REV.
B

SAE AS150801
THRU AS151100

STUD, STEPPED. 1.5 DIA ENGAGEMENT,
CADMIUM PLATED, STEEL UNS G87400,
.3125-18 UNS X .2500-28 UNF-3A

ISSUED 1999-12 REVISED 2012-04

FIGURE 1 - STUD

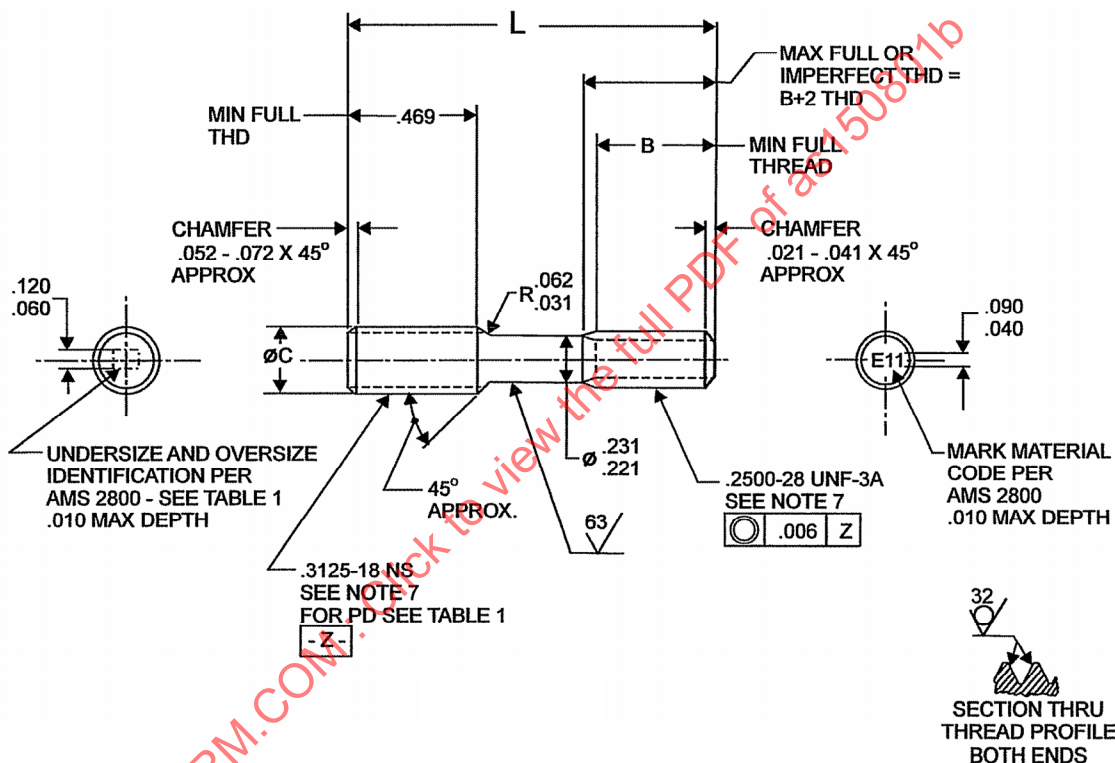
REVISE MARKING IDENTIFICATION TO MAKE USE OF "+" SYMBOL ON OVERSIZE STUDS OPTIONAL AND CORRECT TYPOGRAPHICAL ERROR FOR C DIM FOR +.012 OVERSIZE PART IN TABLE 1.

(2) MARKING IDENTIFICATION FOR OVERSIZE PARTS MAY INCLUDE A PLUS SIGN (“+”) BEFORE THE IDENTIFICATION NUMBER. FOR EXAMPLE, PARTS FOR +.006 OVERSIZE MAY BE MARKED “6” OR “+6”.
